Lot 667 Woodmont, Preliminary Plan, 120150050

Kathleen A. Reilly, AICP, Planner Coordinator, Area 1, <u>Kathy.Reilly@montgomeryplanning.org</u> , (301) 495-4614
\mathbb{C}	Elza Hisel-McCoy, Supervisor, Area 1, Elza.Hisel-McCoy@montgomeryplanning.org , (301) 495-2115
PAK	Robert Kronenberg, Chief, Area 1, Robert.Kronenberg@montgomeryplanning.org, (301) 495-2187

RECOMMENDATION: Staff recommends approval of Preliminary Plan 120150050 for a maximum of 25,259 square feet of non-residential development on Lot 667, subject to the following conditions:

Figure 2 Proposed Preliminary Plan

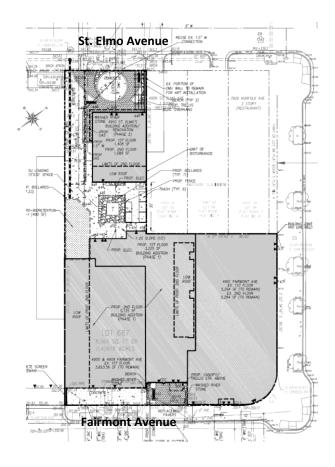
The only vehicular access to the Property will be for loading and deliveries from a driveway adjacent to 4910 St Elmo Avenue. No vehicular parking is proposed on-site. The Property is located in Bethesda Parking Lot District (PLD) and the Applicant will make a payment to the PLD in lieu of providing on-site parking spaces. Pedestrian access will be provided from existing sidewalks on Fairmont, St. Elmo, and Norfolk Avenues.

Figure 3 Fairmont Avenue Public Use Space

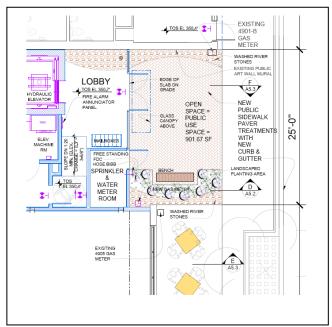
The Applicant is proposing 1,877 square feet of public use space which will meet the 10% public use space requirement for the Standard Method of Development under the CBD-2 Zone. As shown on Figures 3 and 4, the public use space will be located along portions of the Property's frontage on Fairmont and St. Elmo Avenues.

Figure 4 St. Elmo Avenue Public Use Space

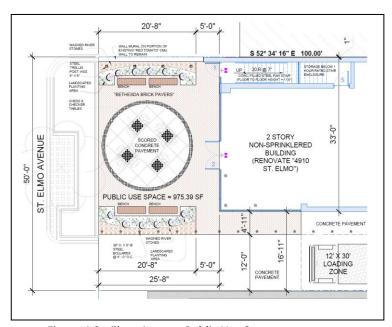
Additionally, the Applicant is proposing public art, a freestanding panelized mural, to be located adjacent to the northern edge of the Property's sidewalk along the St. Elmo Avenue frontage.

- The Applicant must provide a minimum of 10 percent of the net lot area as public use space, including as public art a free-standing panelized mural or Staff approved alternative, to be located adjacent to the northern edge of the Property's sidewalk along the St. Elmo Avenue frontage, as illustrated on the Preliminary Plan. Installation of this art work must occur prior to the issuance of final use and occupancy permits. Before issuance of any above-grade building permit for this site, the Applicant must present the public art to the Planning Department's Art Review Panel for review and comment.

Figure 5, Woodmont Triangle Amendment Boundaries, Block by Block Diagram

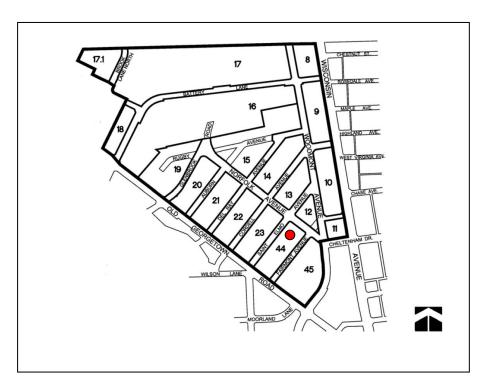
The Property is located within in Block 44 of the Amendment area, see Figure 5. For this block, the Plan recommended increasing the allowable residential density on the site to promote higher-intensity redevelopment.

The Amendment strongly encourages higher intensity redevelopment; specifically residential uses on CBD zoned properties. In the absence of providing residential uses, the Plan states that any non-residential development on CBD zoned properties are limited to a maximum FAR of 1.0. The proposed Preliminary Plan includes only non-residential uses, thus, the lower-scale non-residential development is limited to a 1.0 FAR. The Application also proposes retaining small scale retail uses and providing other types of first floor uses that will activate Fairmont and St. Elmo Avenues, both goals of the Amendment. The addition of six bike racks along St. Elmo Avenue will also improve bicycle connections in the adjacent neighborhoods and to the Metro Stations. Therefore, the Application is in conformance with the recommendations of the Woodmont Triangle Amendment.
